PLANNING TECHNICAL REVIEW COMMITTEE –AGENDA

TECHNICAL REVIEW COMMITTEE MINUTES – WAIV-2023-0004

Application Type: Site Review
Applicant(s): Kniphfer LLC
Owner(s): Kniphfer LLC
Location: 43 Back River Road (Tax Map I, Lot 55-A)
Date: June 22, 2023

A&M Project #: 3188-01
Re: TRC Response
Tax Map I, Lot 55-A
43 Back River Road

2 EXTERIOR ELEVATION - REAR

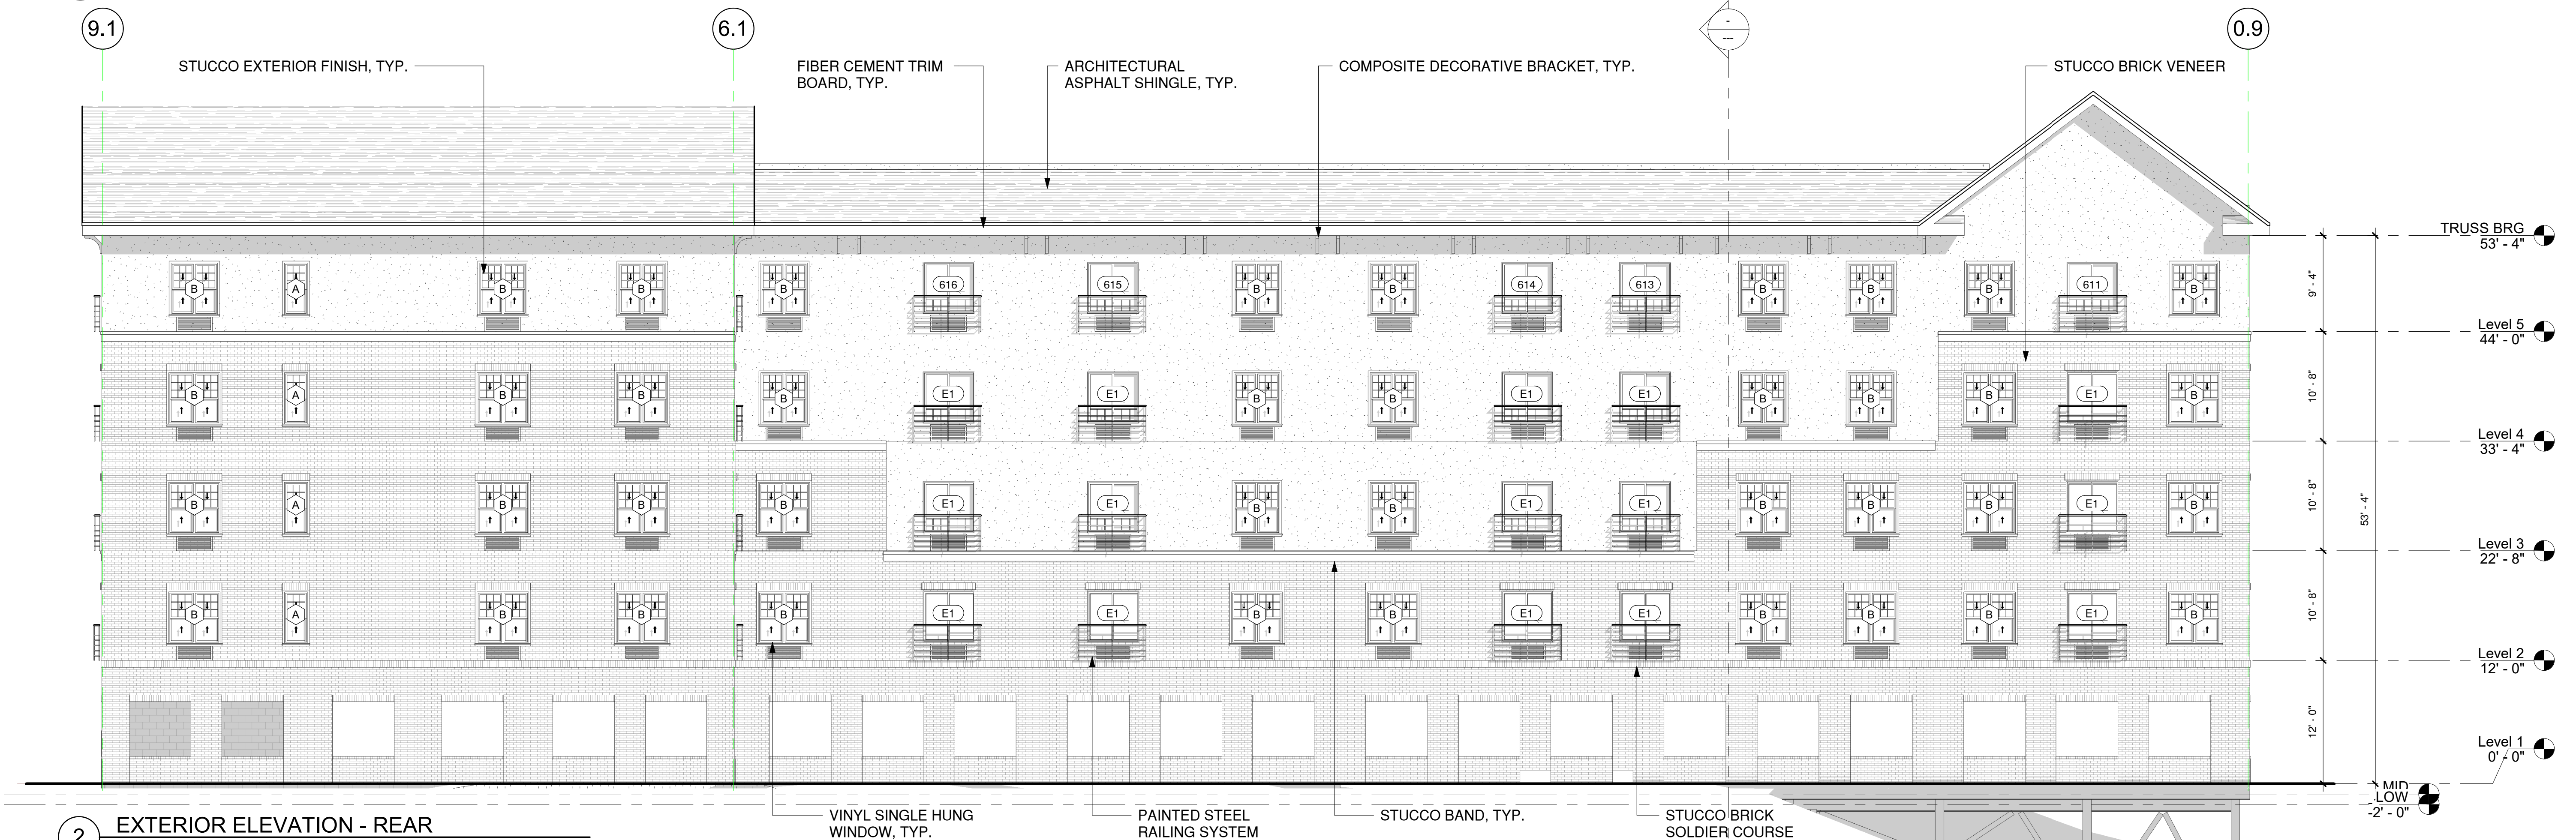
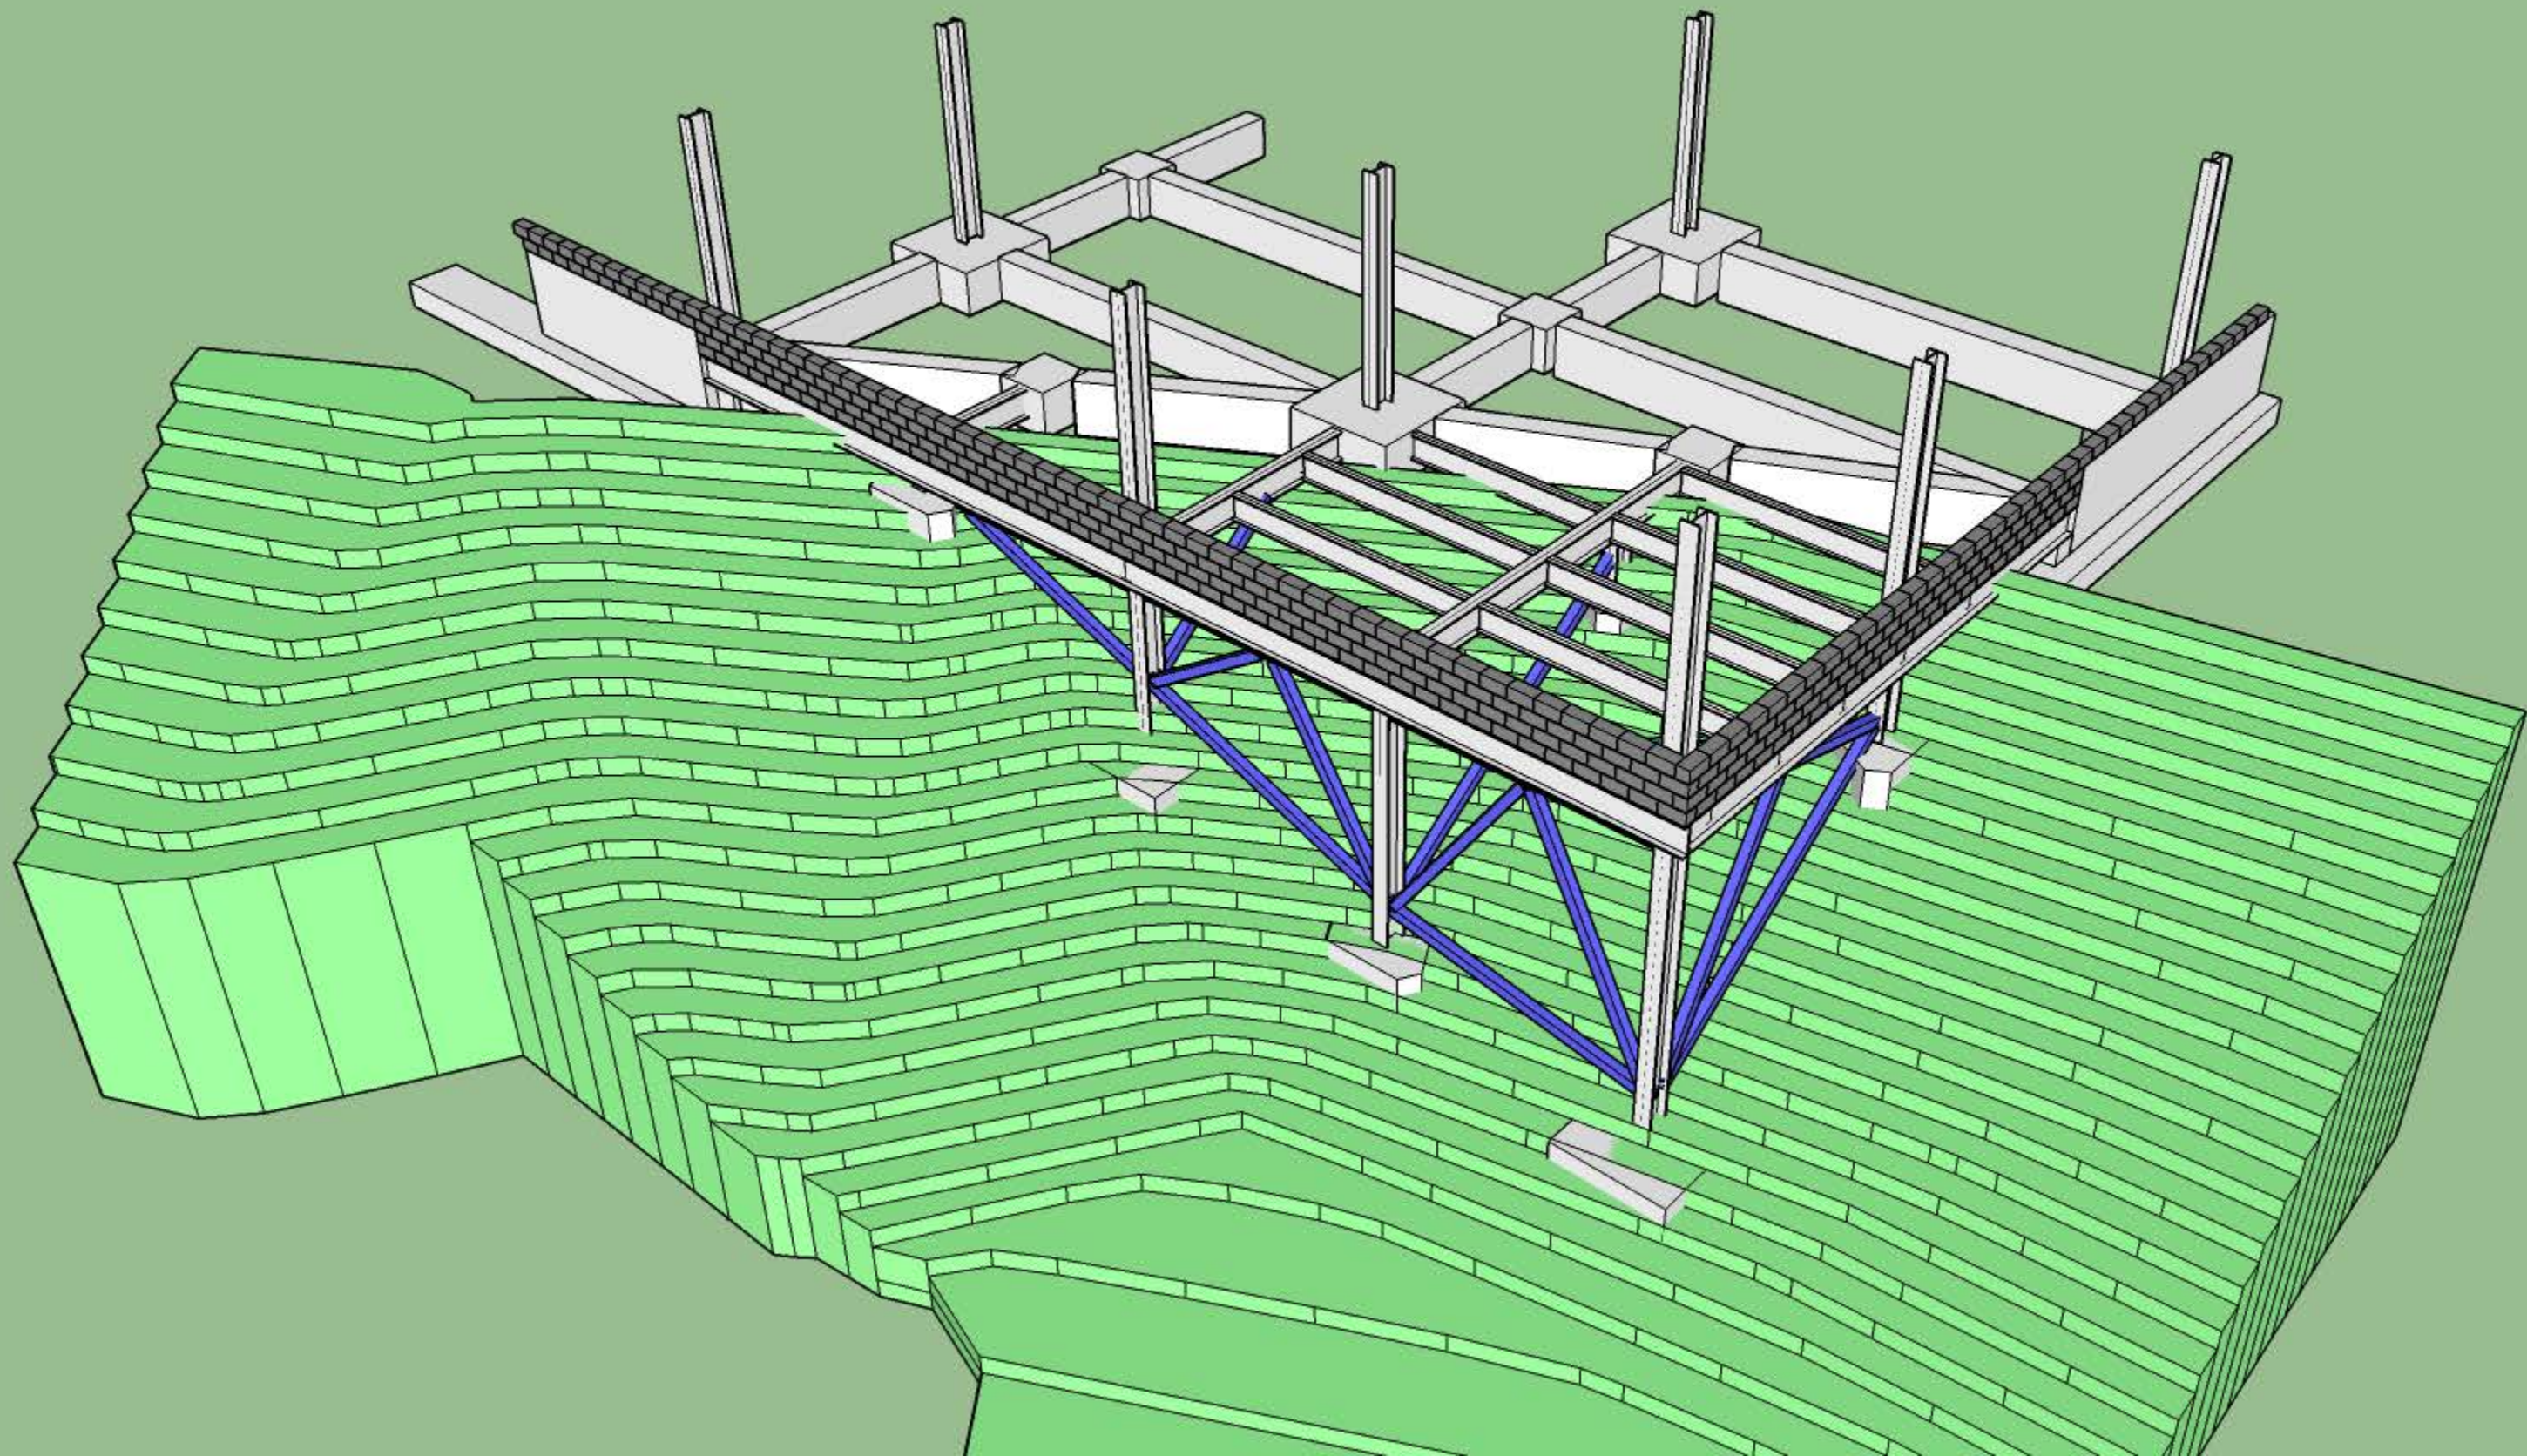
The proposal is to remove the wall from the project along with the connecting walk. The above grade deck will remain but is supported by the building and any additional peers that may be needed per the structural plan. Enclosed is a rear elevation of the revised building and a wireframe view of the structure adjacent to the slope. Based on the peer design there is no need for the wall to be installed.

Working with the project Geotechnical Engineer, Harry Wetherbee, PE, it was determined that the slope can be reinforced with a rip-rap lining. This lining will allow the slope to remain stable and allow the small amount of roof to discharge without causing erosion over time. The majority of the roof is designed to be flat and internally draining, with small mansard roofs proposed along the perimeter.
